ADDENDUM TWO

1ST FLOOR OFFICE FIT-OUTS PHILIP NOEL JUDICIAL COMPLEX 222 Quaker Lane Warwick, Rhode Island

September 30, 2016

FIRST FLOOR PLAN -TEL ROOM 1107 LOCATION

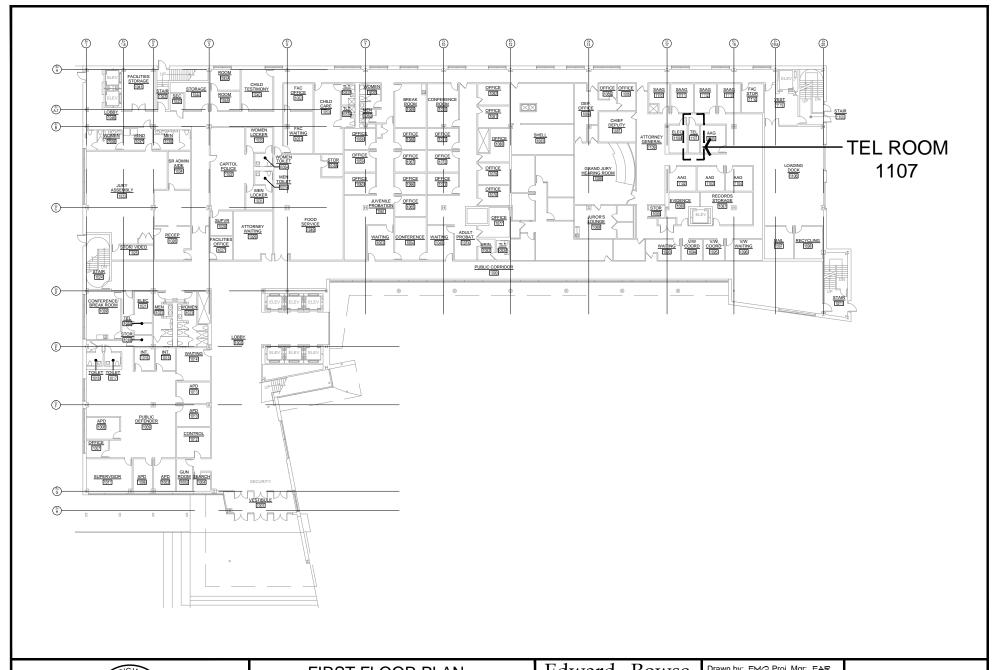
Answer: No, but the owner is not responsible for any materials or equipment.
- 16. Where on the Key Plan is Tel Room 1107?

Answer: Please see the attached sketch entitled "SK1.0 – First Floor Plan - Tel Room 1107 Location" dated 09.29.16.
